## KINGSTON FOSSIL PLANT

ANNUAL ASH POND DIKE  
STABILITY INSPECTION  
2009

Prepared by: Chris Buttram  
Date: January 12, 2009

Fig. 3 Discharge to Stilling Pool

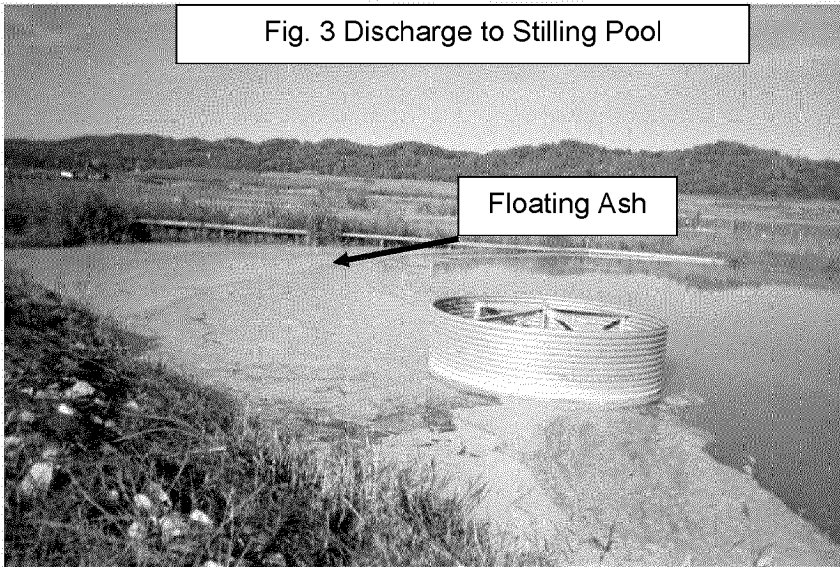
Floating ash near discharge structures, as seen in Figure 3 below, should be removed immediately to prevent an accidental release. Check the floating skimmer booms and maintain them to keep floating ash away. The seeps reported on the bench of Dike "C" north of the intake skimmer have not been reported since wheel ruts were repaired a few years ago. No seeps or wet spots were seen in this area during the inspection.

Fig. 4 Typical Erosion on Road

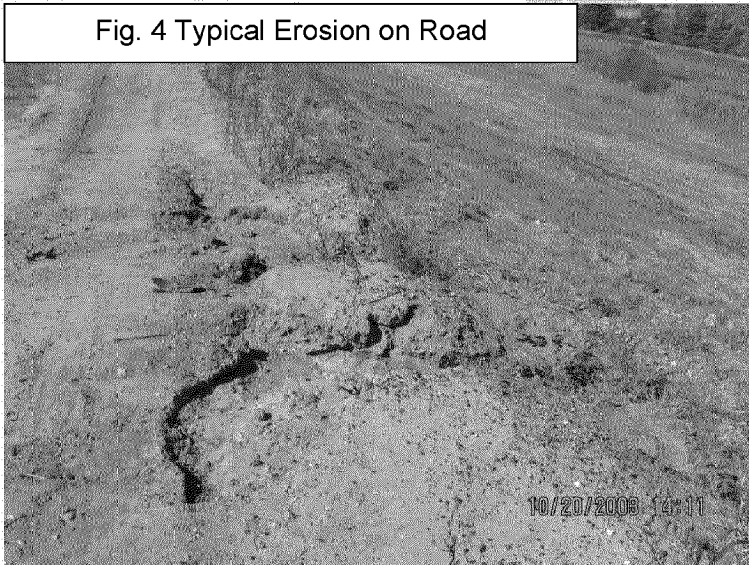
Some of the dike roads exhibit areas of erosion on the edges and some rutting, see Figure 4. This photo is typical of the eroded areas of the roads. Although it does not appear to be a significant problem, these eroded areas, as well as any ruts, should be graded out and the road covered with crushed stone to prevent larger erosion gullies.

- Repair rutting in the access and dike roadways, as well as benches. Fill with bottom ash and regrade as required to promote drainage.
- Repair broken dewatering well outlet pipes. These pipes should be draining directly into the lined ditch at the bottom of the cells.

Fig. 5 Ash Pond Internal Dike

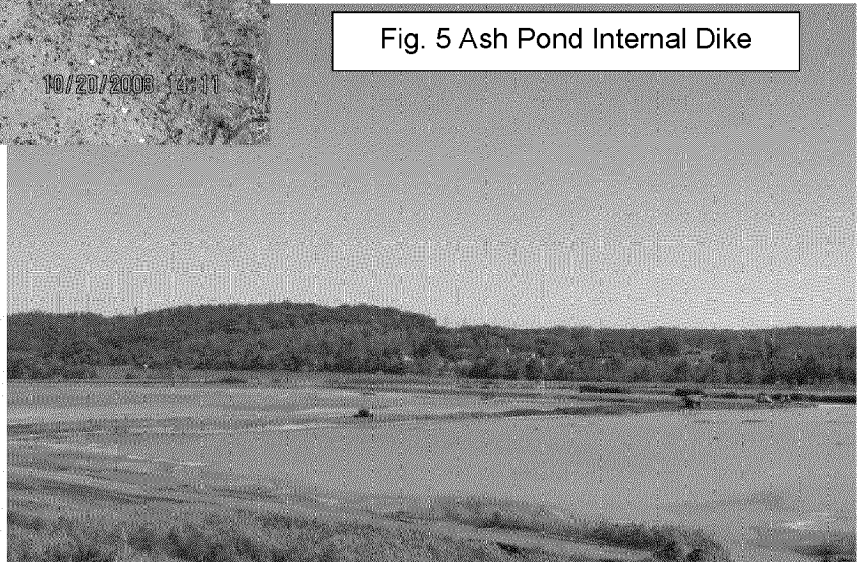
Construction of an internal divider dike inside the active ash disposal area is currently underway. The dike is 1 foot to

2 feet above elevation 760, the elevation of the water in the pond. The divider dikes will be constructed to build a base of fly ash for a dredge cell expansion, which will eventually cover approximately half of the existing main ash pond. See Figure 5 to the right.

Fig. 6 Typical Blocked Drainage Path

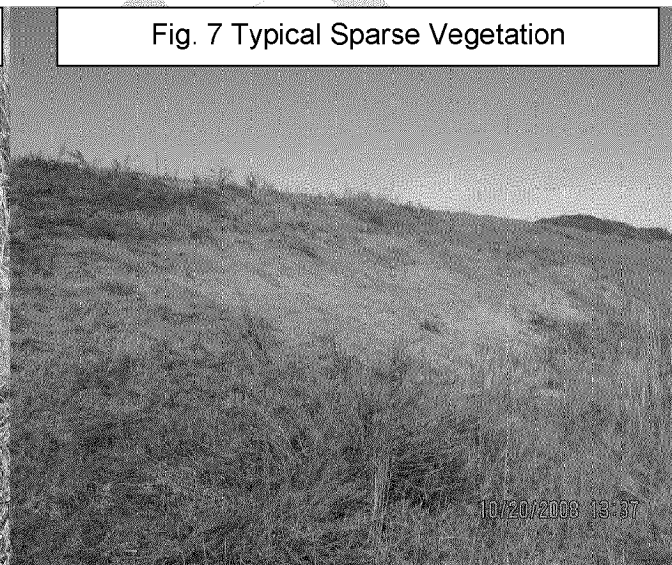
be graded so they will drain, even if slowly. Also, thick vegetation in drainage ditches should be thinned out or removed to keep from blocking the water flow. See Figures 6 and 7 above. Wheel ruts on benches or in a road that are holding water should be filled with bottom ash and covered with stone. Due to extensive erosion in one area, an erosion washout of 2 feet wide by 20 feet long by 2 feet deep had formed. This area should be repaired immediately. See Figure 8. Fill bottom layer with 6 inch lifts of compacted bottom ash until clay area is reached. Cap with 1 foot of clay via 6 inch compacted lifts. It is recommended that an erosion control blanket be used in this area for quicker vegetation growth. Monitor this area, especially after rain events, to assure that no settling occurs.

Fig. 9 & 10 Completed Catch Basin & Bench

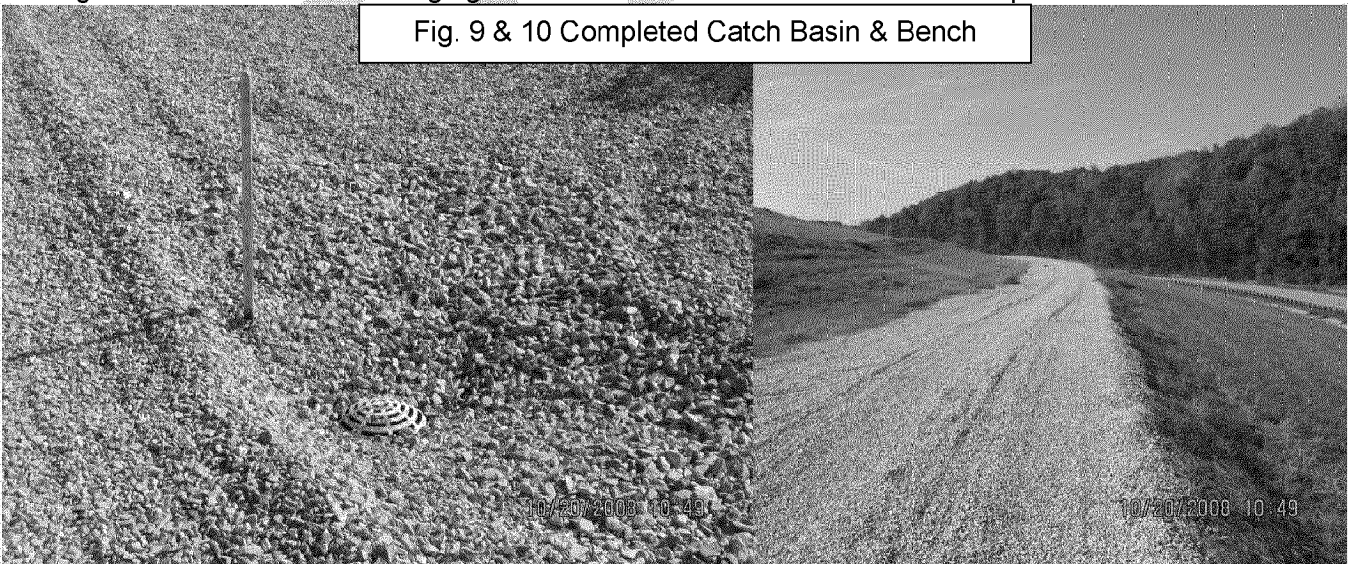
this inspection. Since the last inspection, the lower benches have been re-graded to provide positive drainage to a series of catch basins which will divert the water collected to the lower drainage ditch. In addition to the catch basins and down drains, the benches were covered with a geomembrane, geotextile and then crushed stone to further reduce infiltration into the benches. See Figures 9 and 10 above.

Fig. 12 & 13 Washout on dike bench

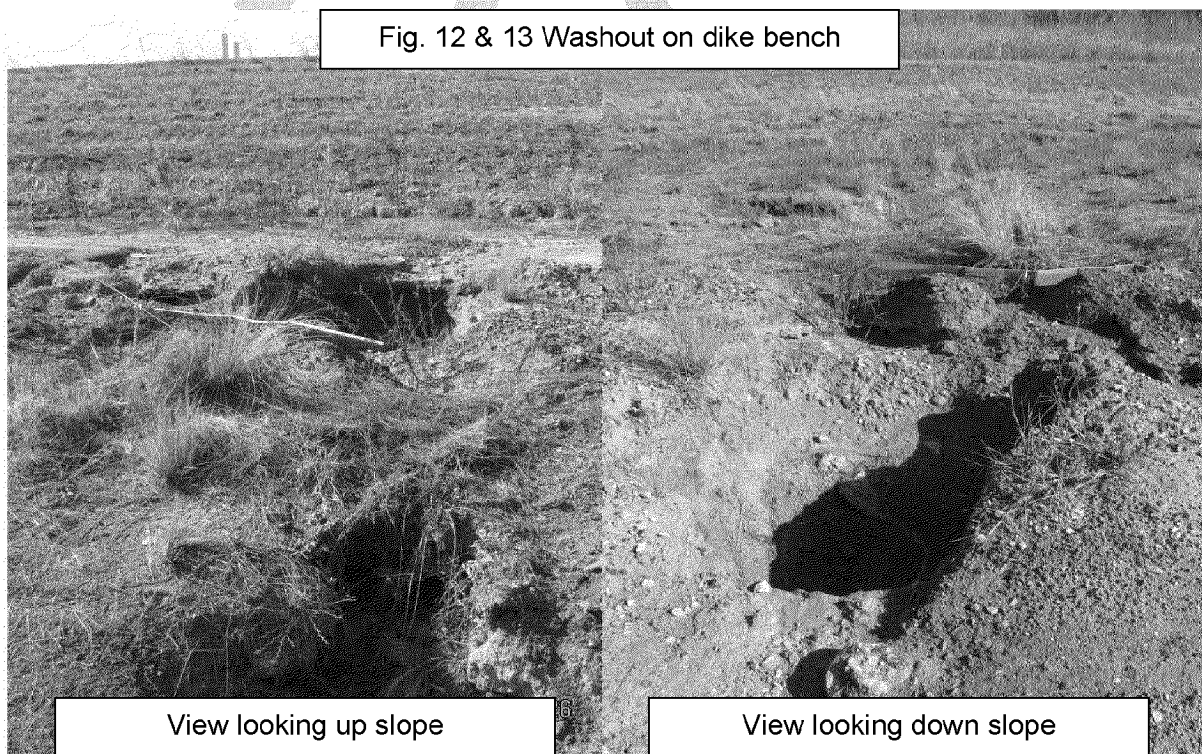
Plant operations have done a commendable job of mowing the dredge cell slopes. Small trees growing on the slopes have been cut level with the ground. If trees are too large to be mowed, the trees should be cut, the stumps removed, and the area backfilled with soil, compacted and seeded and fertilized. Several areas around the dikes of the dredge cells are in need of seeding and fertilizing. It is recommended these areas should be reseeded and fertilized per T-1, section 580. At the north end of the dredge cells, one of the lower dike benches has an area that has eroded and washed out (See Figures 12 and 13 below). This area should be repaired immediately by filling with clay in 6" lifts and compacting. After the area has been filled and compacted, reseed and fertilize per

T-1, section 580. Also at the north end of Cell 2, a small wet spot was noticed at the toe of the bottom dike. This wet spot was roughly 4 feet by 4 feet and approximately 600 feet from the northwest corner of Cell 2. The area was not soft and was believed to be in the spot of an old underdrain. The drain was not located at the time of this inspection. This area should be monitored and if conditions worsen, contact Chris Buttram, 423-751-3574.

- Repair erosion washout on lower dike bench at North end of dredge cells. Repair eroded area by filling with clay in 6" lifts and compacting, then reseed and fertilize per T-1, section 580.

Fig. 16 Check Dams needing repair

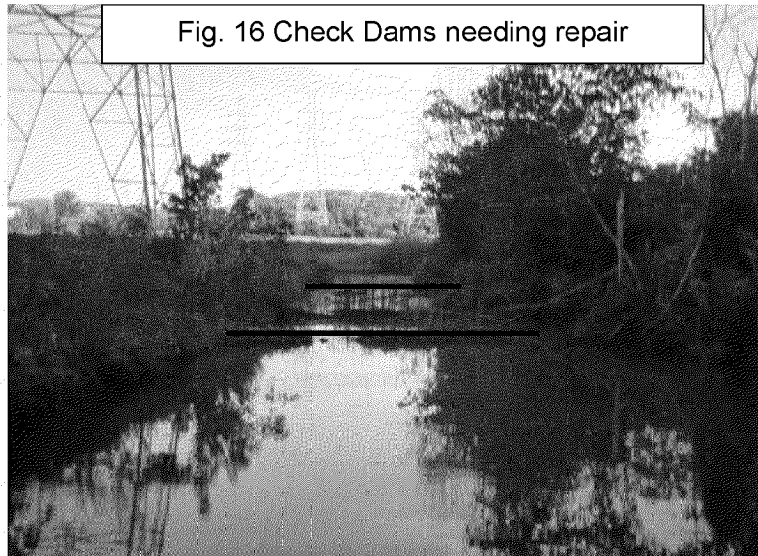
the right shows rock check dams built to keep the coal fines away from the pumps. The check dams appear to be in need of repair and cleaning out. If maintained properly, the check dams will keep sediment from reaching the pumps. TVA drawing 10W225-1 (attached as API 2009-2) shows the pond and its intended bottom contours. The Coal yard drainage basin should be cleaned out annually.

- Dredge the Coal Yard Drainage Basin to restore its design contours and protect the pumps from further damage. There is an estimated 2,800 cubic yards of sediment in the original pond and an extra 3,400 cubic yards in the “V” section that needs to be removed as soon as reasonable. See the attached copy of 10W225-2. Estimated at \$62,000, depending on haul distance.
- Repair and clean out riprap check dams in the coal yard drainage basin to keep solids away from the pumps.

Fig. 17 & 18 Engineered Wetlands

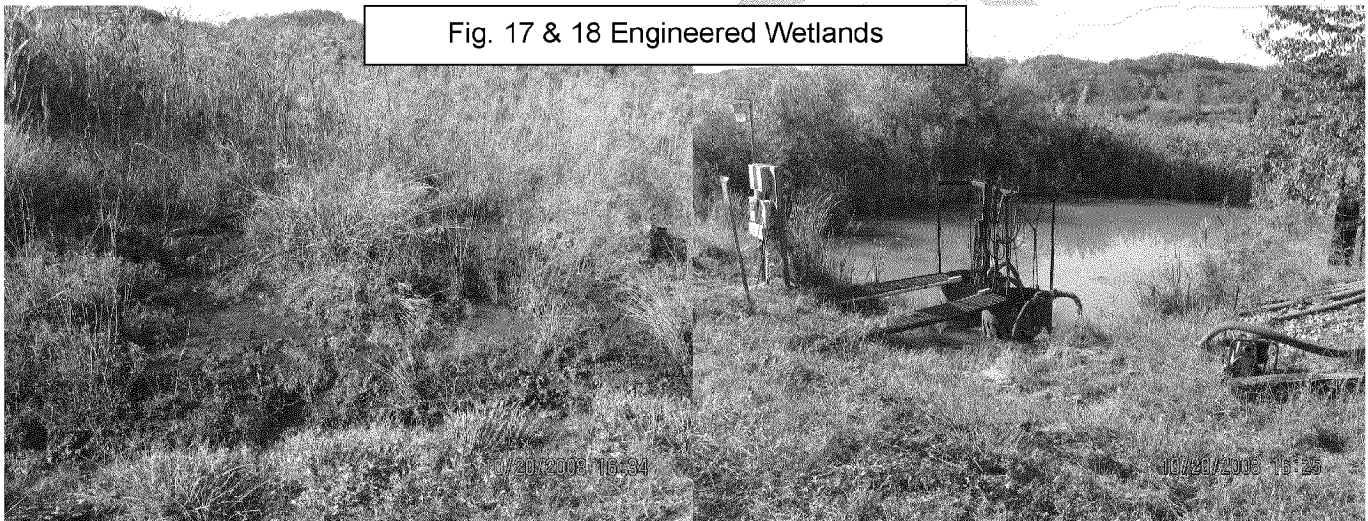
The engineered wetlands along the southwest dike receive seepage that collects in the anoxic limestone drain below the bottom ash trench. The wetland appeared to be functioning, but the discharge is still pumped via two pumps to the ash pond, see Figures 17 and 18 below. Vegetation within the pump structures should be removed so that the pumps do not become clogged. Several trees were noticed along the interior slopes and should be removed by pulling up the roots. Repair the damage by compacting soil into the damaged areas.

- Remove all vegetation from within the pump structures
- Remove trees from the interior slopes. Preventing the trees from getting larger than 1” in diameter at the ground is preferred. Any trees larger than 3” in diameter at the base must be pulled from the dikes, roots and all. Repair and reseed the damaged area.

Fig. 23 Dewatering well overflowing redwater

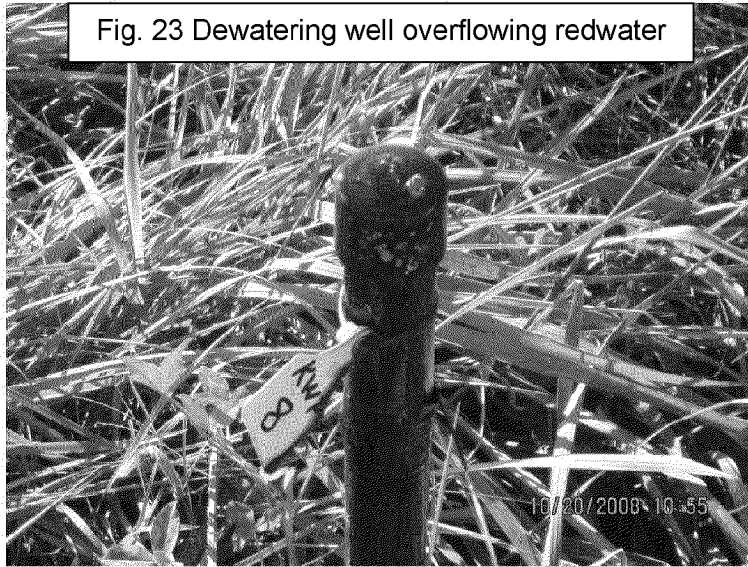
Besides the redwater wetlands, there was only one spot that showed flowing redwater. At first thought to be a seep, it was discovered that the redwater was flowing out of a dewatering well that had a closed valve. The water was flowing down the slope into the riprap ditch. The riprap ditch was also stained some at the outlet area for this dewatering well.
